Detailed Site Plan Ourisman of Bowie

DSP-23026

STAFF REPORT

SUBJECT: Detailed Site Plan DSP-23026
Type 2 Tree Conservation Plan TCP2-089-05-01
Variance to Section 25-122(b)(1)(G)
Ourisman of Bowie

Figure 3: Building Elevations

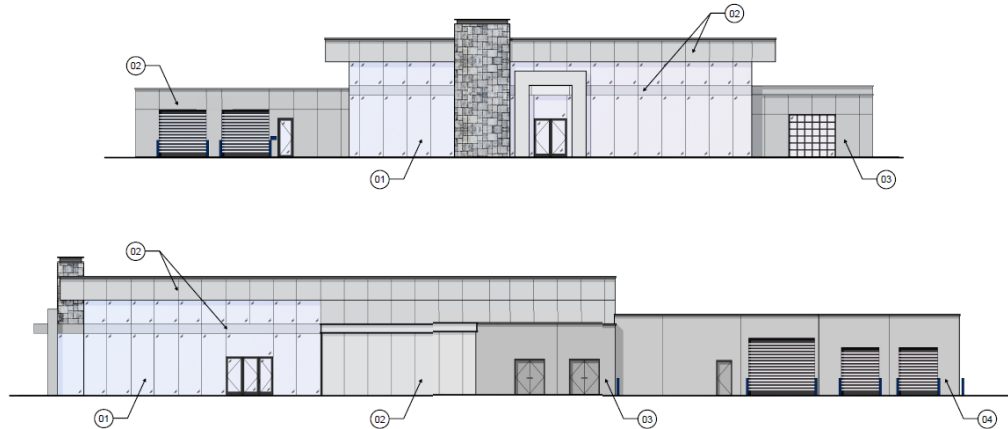
The architectural design of the proposed building is contemporary, with a flat roof. The building façade is finished with a mix of materials, including glazing, masonry, metal coping, aluminum wall panels, and exterior insulation and finish system. The roof features a variety of parapet heights, which breaks up the massing of the building.
